IPC

2024 GROUP A PROPOSED CHANGES TO THE I-CODES

Committee Action Hearings (CAH #2)
October 23 - 31, 2024
Long Beach Convention Center
Long Beach, CA

Figure 4.35 Offset surcharge in a vertical stack

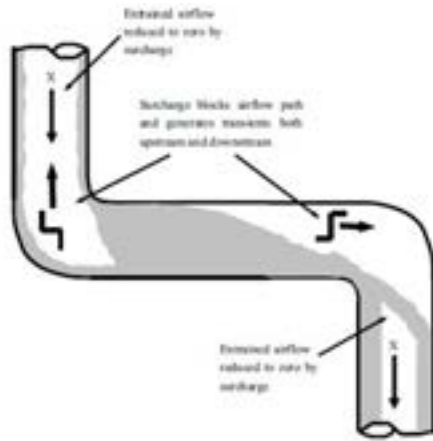
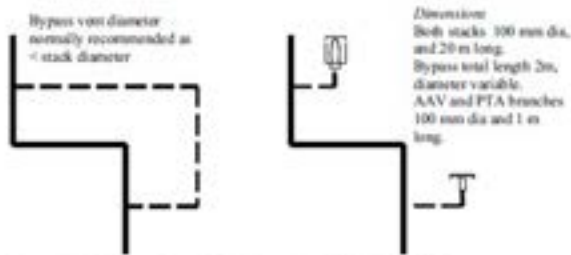
As P127- 24 is for offsets the image attached shows the surcharge event in the offset, and how a vent bypass or the device (PTA pressure transient attenuator) with AAV can vent the offset, which is the purpose of the P127-24 to allow the device with AAV as an alternative venting solution with better or same performance as a bypass vent.

STUDOR Risers with P.A.P.A. Devices and Studor Air Admittance Valves

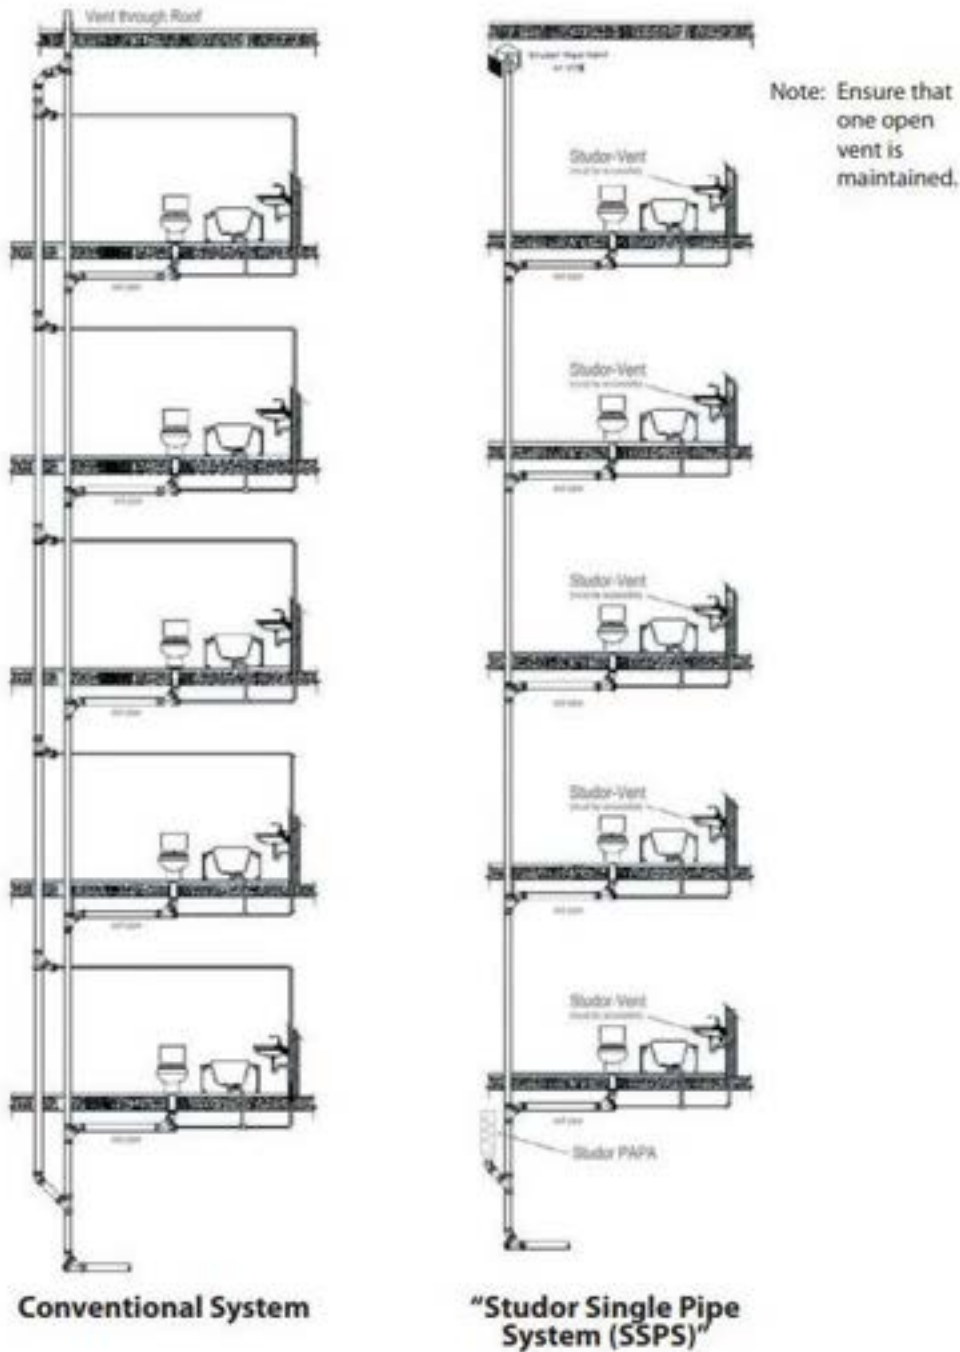
\$1,583.13 cost x 25 stories = \$39,578.25 per stack.

\$39,578.25 cost per stack x 24 stacks in the building = \$949,878.00 total savings.

Figure 1: Smart Toilet

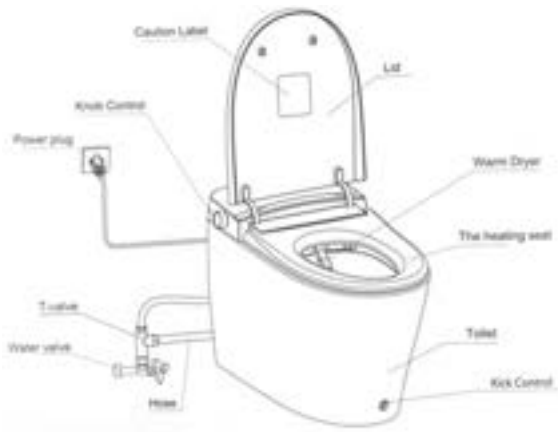
Reason: See CAH1 Proposal P155-24 for extended substantiation supporting the need for potable water use in smart toilets and personal hygiene devices. This proposed change only applies to buildings that chose to plumb non-potable water indoors specifically for toilet flushing. It would require a potable water supply line to be roughed in when the non-potable water supply line is installed to address smart toilets and personal hygiene devices. Smart toilets (See Figure 1) are those which include an integrated bidet feature and personal hygiene devices (See Figure 2) are an add on or toilet seat incorporating a bidet feature. When a residential building is plumbed with a non-potable water supply line to the toilet, residents opting for a smart toilet or personal hygiene device must connect to the available non-potable water supply or re-pipe with a potable water supply line for proper installation. This can be expensive after move-in but can be economically addressed during initial construction. Personal hygiene devices and smart toilets are crucial for many Americans with medical conditions, special needs or limited mobility. An allowance in the existing code to include provisions for these products is important to ensuring public health and safety. The water quality used with smart toilets and personal hygiene devices must be free of any pathogens that could cause infection or disease and, therefore, must be treated at a minimum in accordance with regulations for potable water.

Figure 1: Smart Toilet

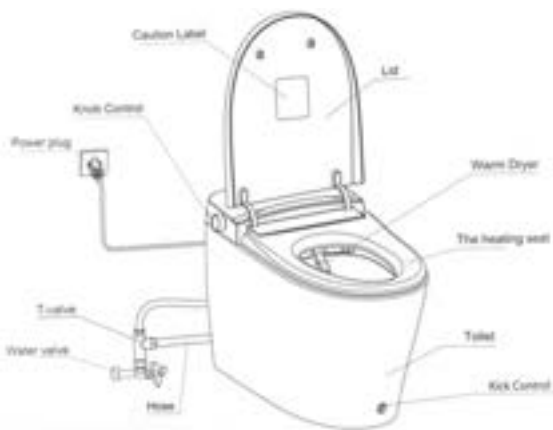
This proposed change only applies to buildings that chose to plumb non-potable water indoors specifically for toilet flushing. It would require a potable water supply line to be roughed in when the non-potable water supply line is installed to address smart toilets and personal hygiene devices. Smart toilets (See Figure 1) are those which include an integrated bidet feature and personal hygiene devices (See Figure 2) are an add on or toilet seat incorporating a bidet feature.

Personal hygiene devices and smart toilets are crucial for many Americans with medical conditions, special needs or limited mobility. An allowance in the existing code to include provisions for these products is important to ensuring public health and safety. The water quality used with smart toilets and personal hygiene devices must be free of any pathogens that could cause infection or disease and, therefore, must be treated at a minimum in accordance with regulations for potable water.
